January 30, 2006

Project Texas Roadhouse Madison, WI
Project # 20050922.2
Re Resubmittal: Urban Design Review

Please note the following revisions to the documents listed above:

Sheet Number: **1** Of **3**

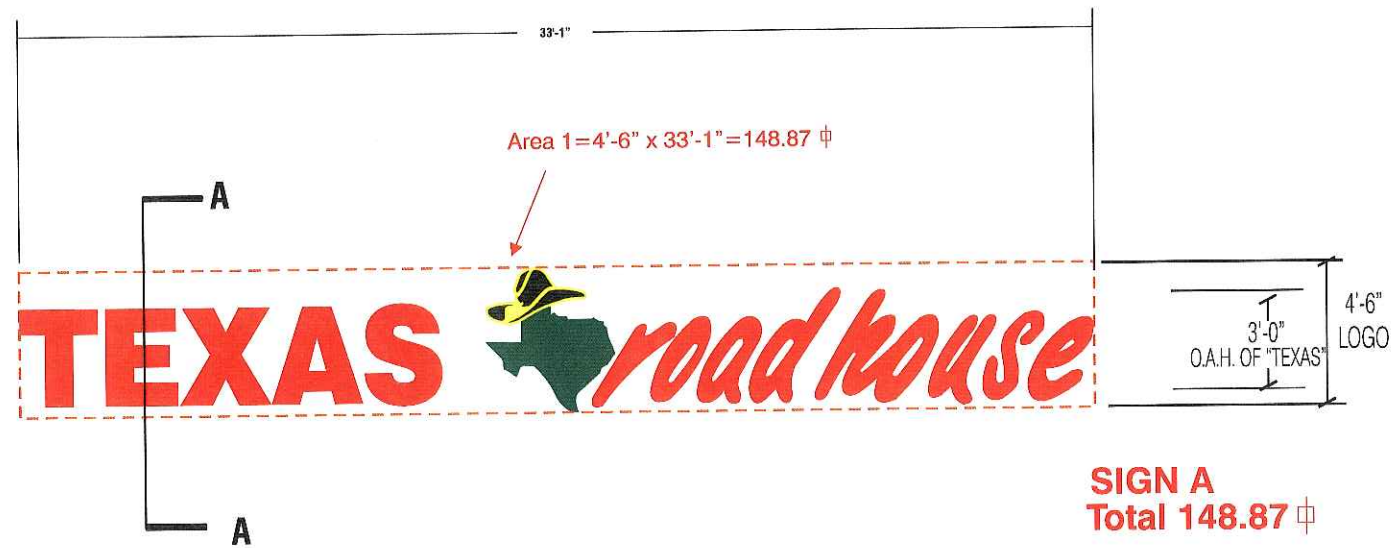
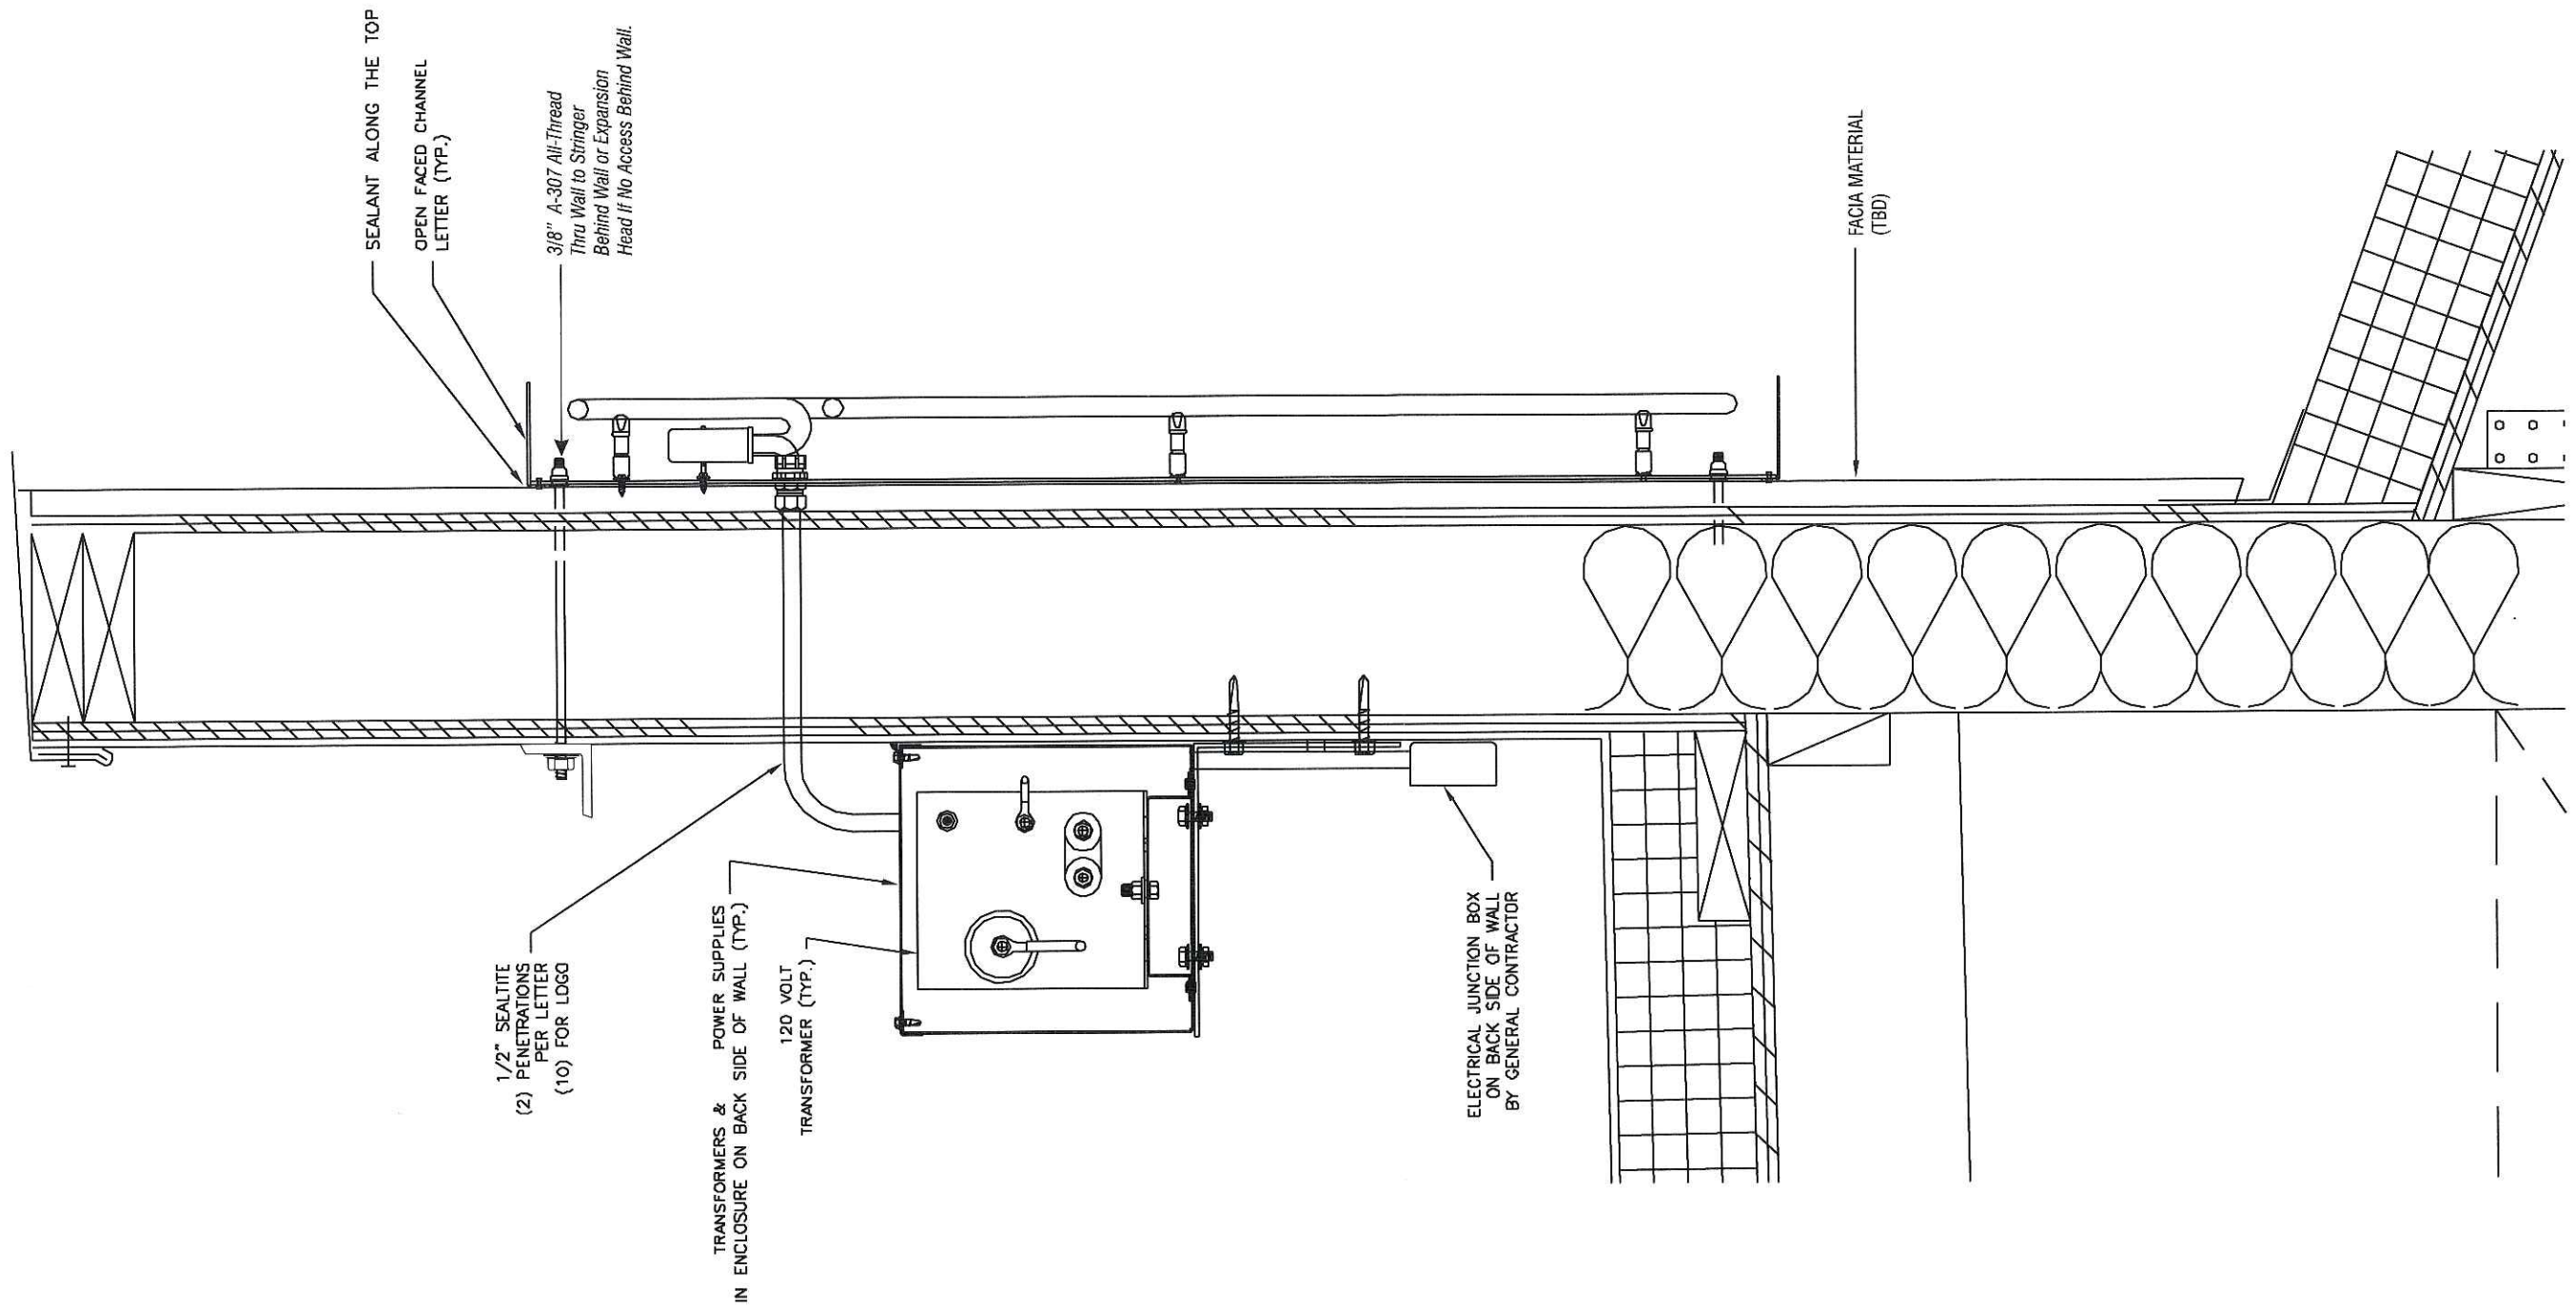
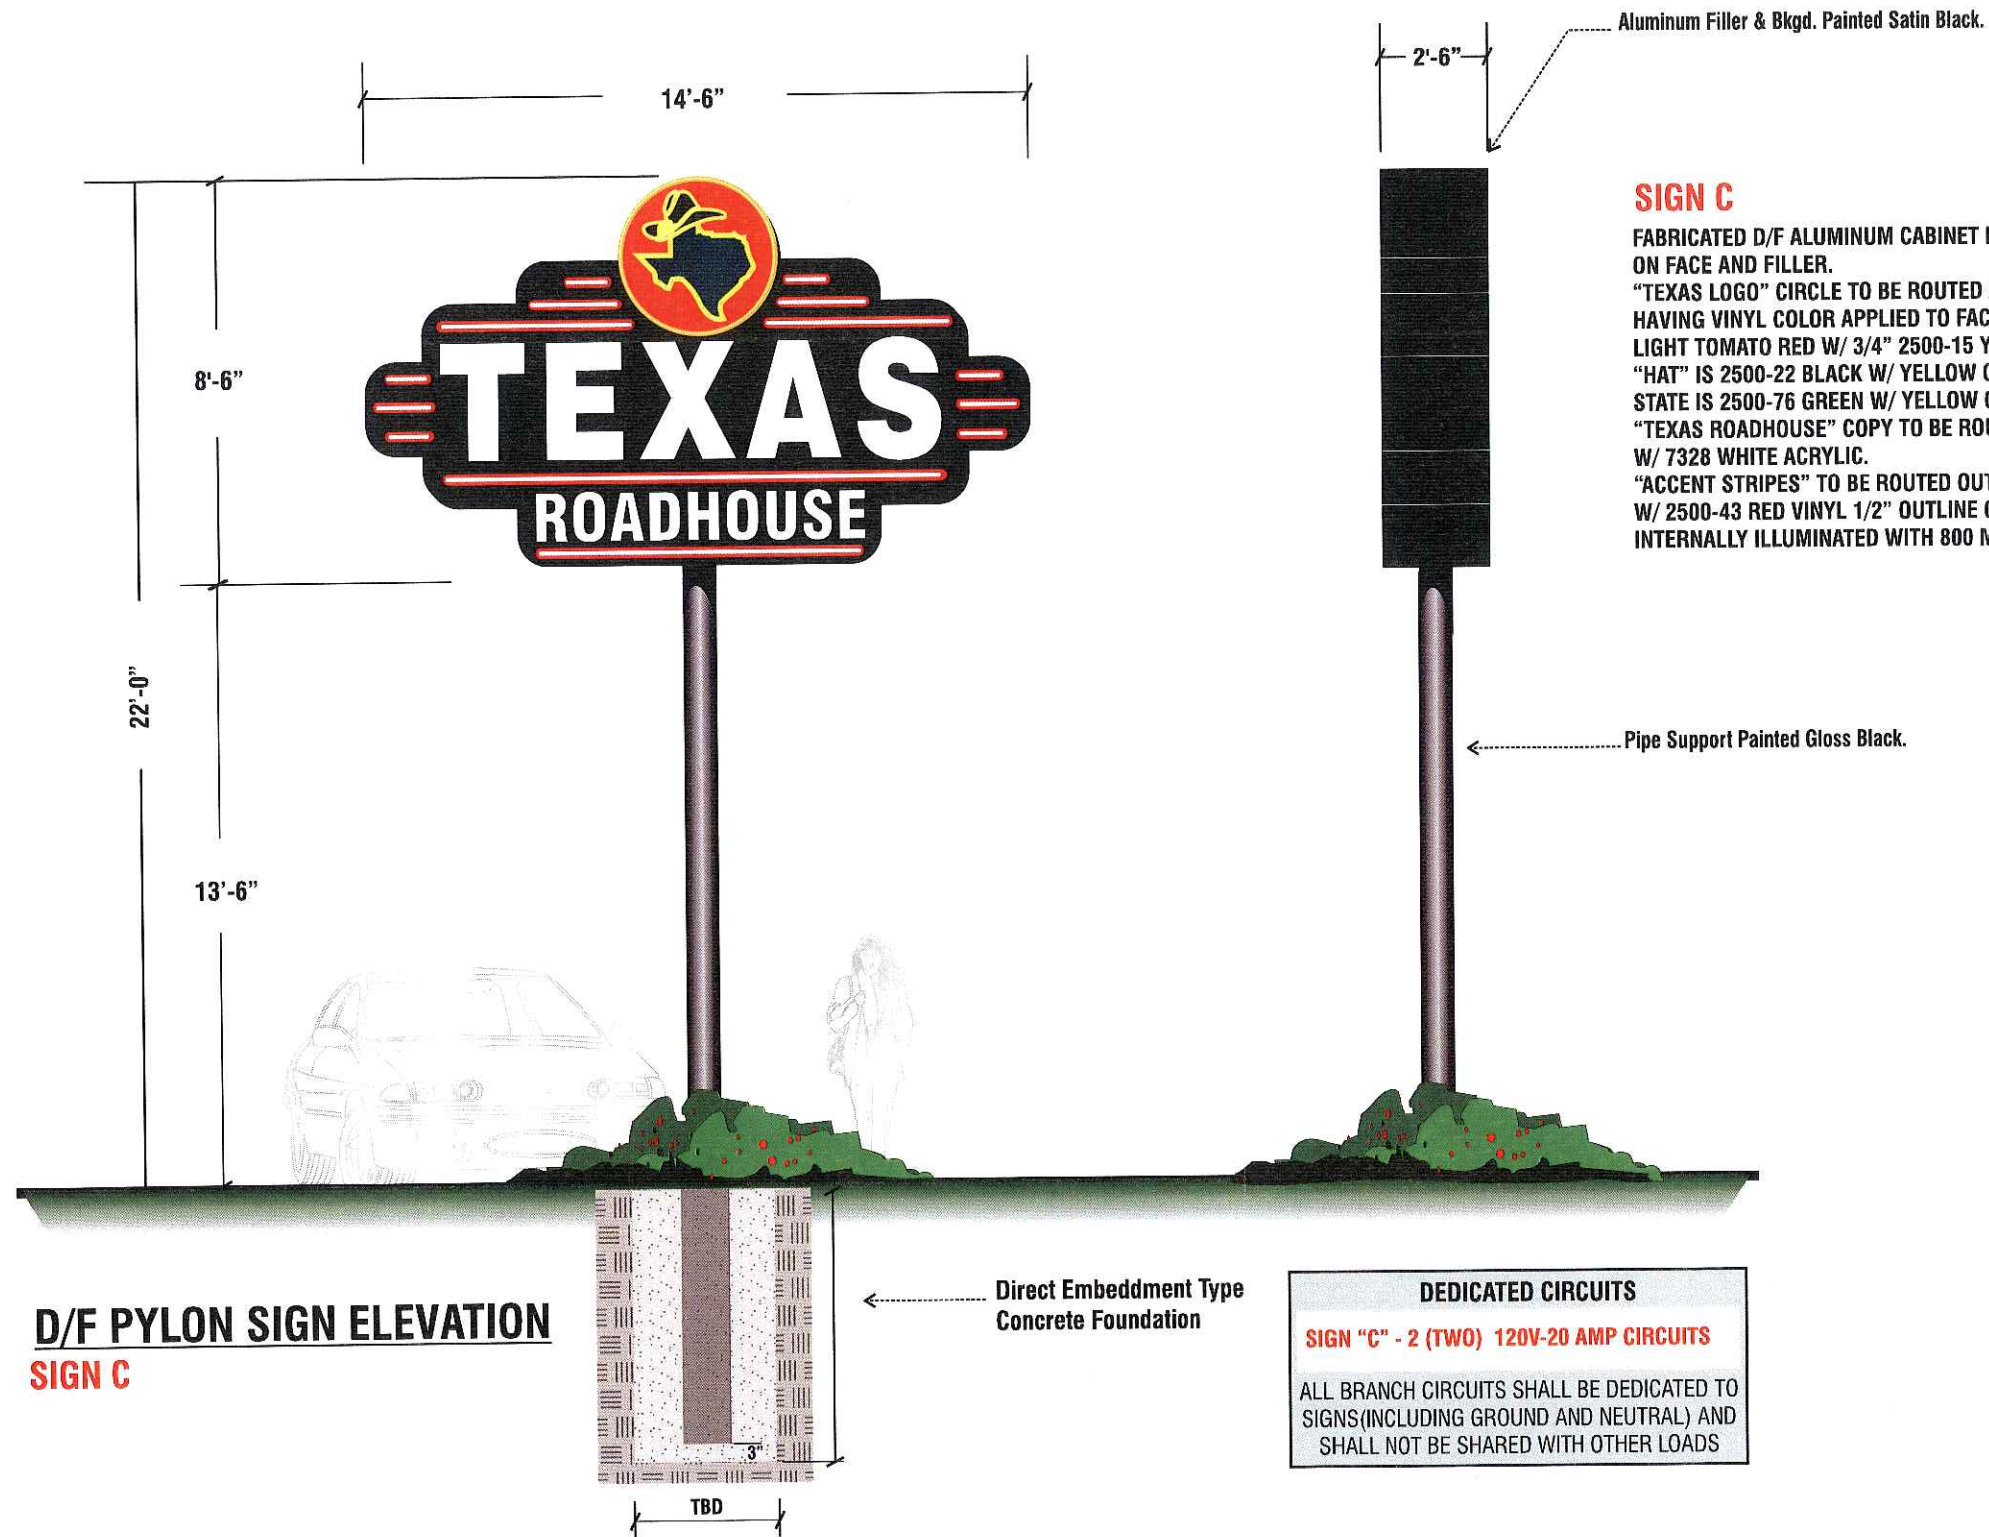
4. The signage exhibit has been revised to show that the exposed neon of the large wall sign is recessed within the "can." Also, the pylon sign and small wall sign above the entrance door were revised to be internally lit cabinets.
